Project Name: ADAMS SCHOOL SITE RE-DEVELOPMENT

Review Type: *Level III*
 MAJOR SITE PLAN WITH SUBDIVISION

Project Name: Adams School Site Re-Development - Proposed Lighting
Project ID: 10-99700009
CBL: 003-H-001-001
Project Address: 48 Moody Street, Portland

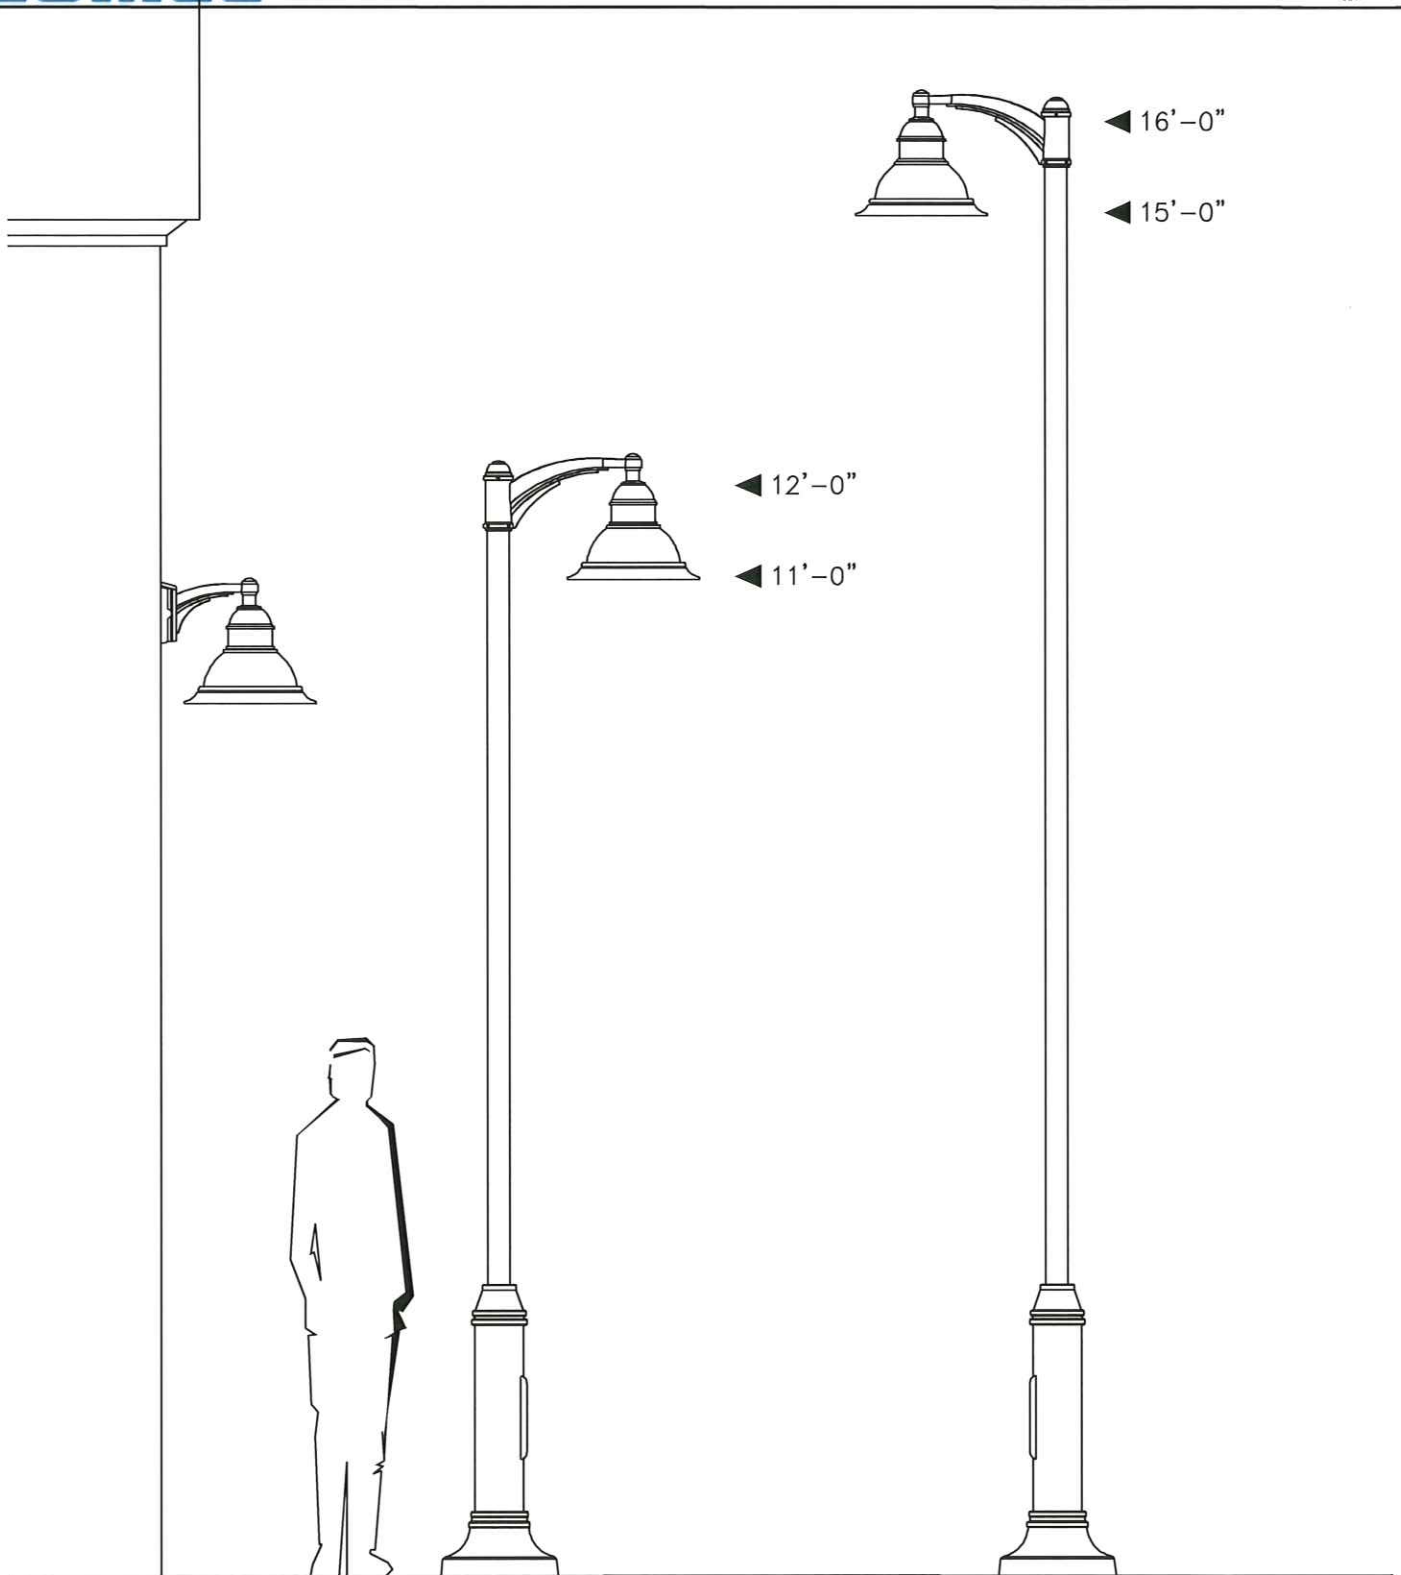
I wanted to check in with you all regarding the street and park lighting for the Adams School Redevelopment Project. We are proposing several street lights and interior park lighting along the esplanade. The City of Portland Technical Manual calls for a 14'-4" Town and Country pole. The standards also indicate that the fixtures should be full cut-off, which I am not sure is consistent with the Town and Country style fixtures. I also understand that the City is moving toward using LEDs and owning lights rather than leasing from CMP. That said, I have reservations about specifying the Town & Country pole and fixture. Could you weigh in?

I had provided Dave with information on a Lumec (Phillips) fixture that is LED (4,000K) and full cutoff as an alternative for the City's consideration. I am hoping that you could give some guidance on the City's preference for street and park lighting in this location since we will be making our next submittal in January. I've attached the information for your review. Since this would be an alternate to the standard, I'm wondering how the process works? Could you advise? Thanks.

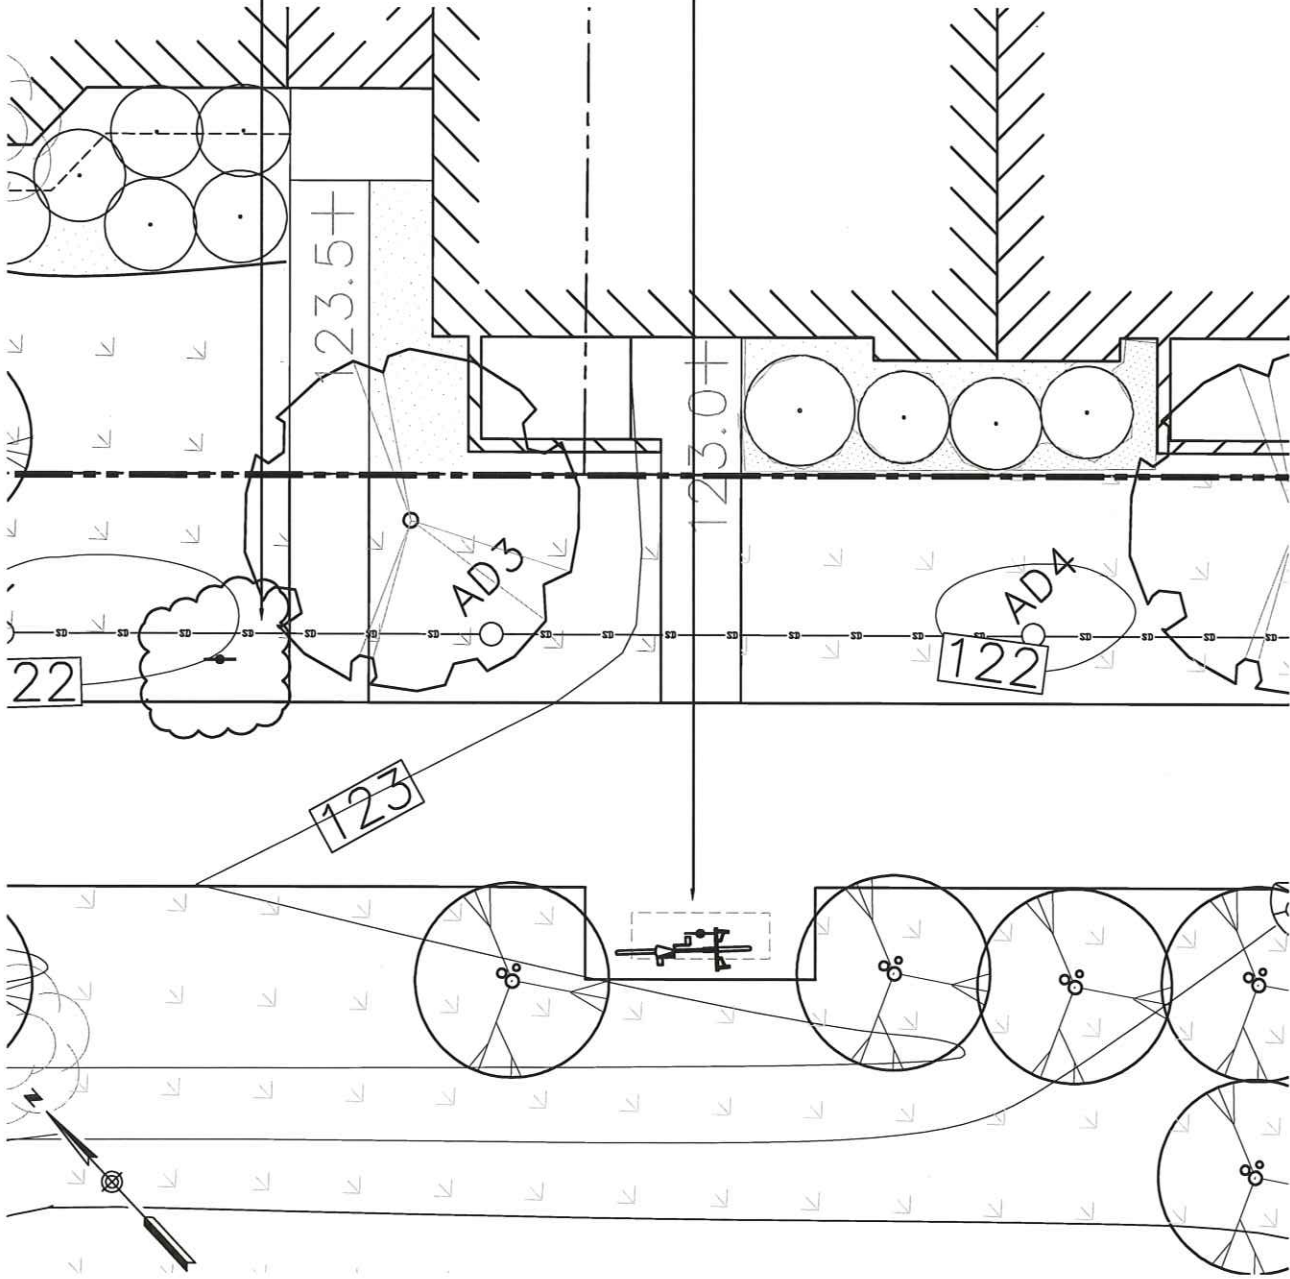
For the reasons given above, we would like to request permission to eliminate the bench along the esplanade. Avesta will donate the bench to the City so that it can be installed elsewhere. Additionally, we'd like to leave the current bench pad in place and relocate one of the bike racks to this location, which offers more room. Please refer to the attached sketch showing the proposed changes.
